Leese Neville Alternator Stud Cable Arrangement

For Volvo and Mack trucks equipped with the Leese Neville Alternator and an engine pre-heater, the arrangement of the cables may result in not having full engagement of the fastening nut on the mounting stud.

Stack-up on Alternator terminal (After with pre-heater cables)

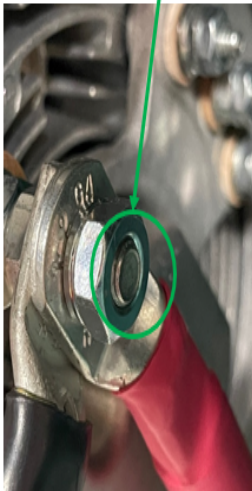
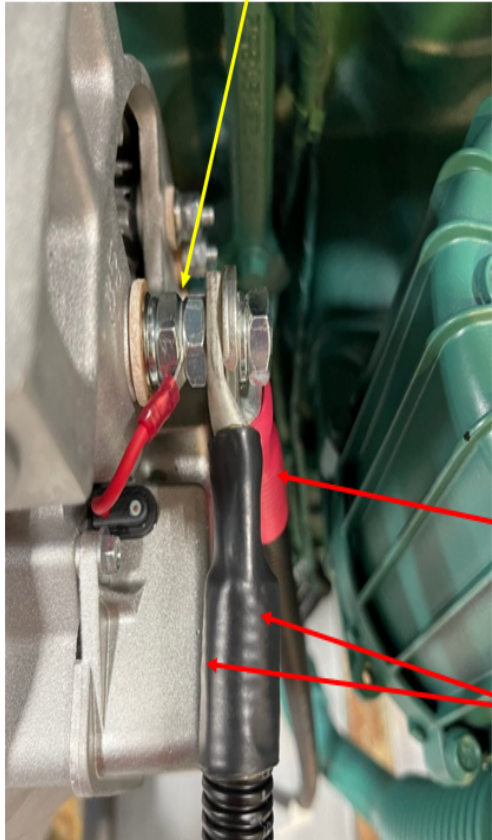
Remove the lock washer and flat washer seen below.

Ensure Starter to Alternator cable (Bottom cable. Keep it away from the alternator housing.) is spaced away from the alternator housing.

Remove flat washer and lock washer from middle assembly keeping the rest of the hardware and torque the same.

Thread engagement OK

Pre-Heater to Alternator cable (top cable)

Starter to Alternator cable (bottom cable keep it away from Alternator housing)
